SUBJECT: Forwards responses to NRC questions re small bore pipe.
 Twelve oversize drawings encl, including three illegible.
 Aperture cards are available in PDR.

SUSQUEHANNA STEAM ELECTRIC STATION
SMALL BORE PIPE QUESTIONS
ER 100450 FILE 285
PLA-1298

Docket No. 50-387

SPA 1312 (STUDY CALCULATION)

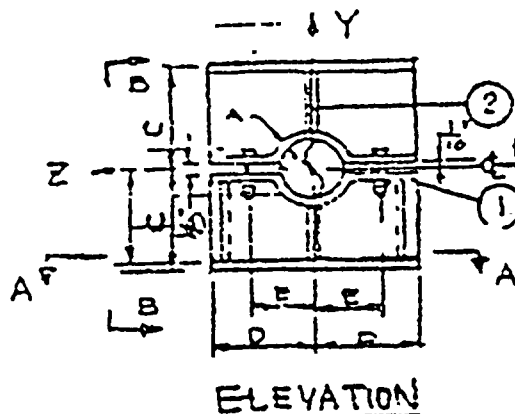
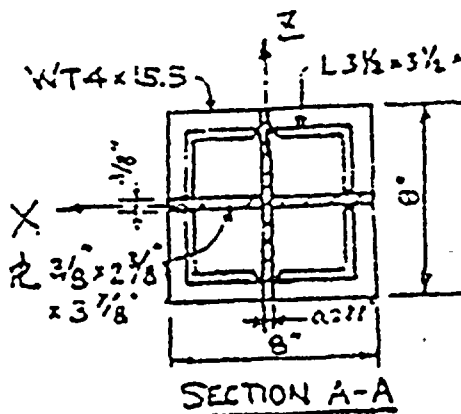
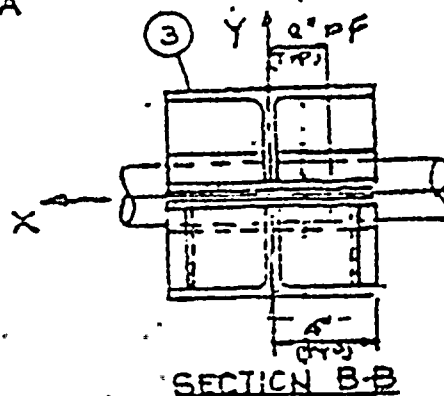
The old Detail 600 uses SA-307 Bolt of lesser strength than SPA-600 and SPA-1312 drawing implying that the bolt clamping force in detail 600 is less than the new design. Additionally the allowable anchor torsional moment on SPA-600 and 1312 was reduced. Provide a justification that the Detail 600 is still acceptable to function as a pipe anchor.

Detail 600 anchor does not specify any bolting material. The bolting material used on installation of detail 600 is SA-307. These bolts (SA-307) are qualified per attachment 1 for use on detail 600 for the allowable loads. Additionally, use of SA-325 bolts on SPA-600 and SPA-1312 does not result in higher allowable loads (higher clamping forces).

During the As-built Reconciliation, the least allowable loads (as listed on revision 2 of SPA-600) were used when reviewing the Detail 600 or SPA 600's called out on the hanger drawings. If the allowables were exceeded, a fix was implemented.

The allowable torsional moment (M_x) shown for the detail 600 was not reduced for the SPA-600 and SPA-1312. The moment about the "Y" axis was reduced for the SPA-600 only. The reduction of the allowable moment about the "Y" axis is not a function of either the clamping force or the bolt material. The reduction is associated with the structural strength of the lower half of the anchor.
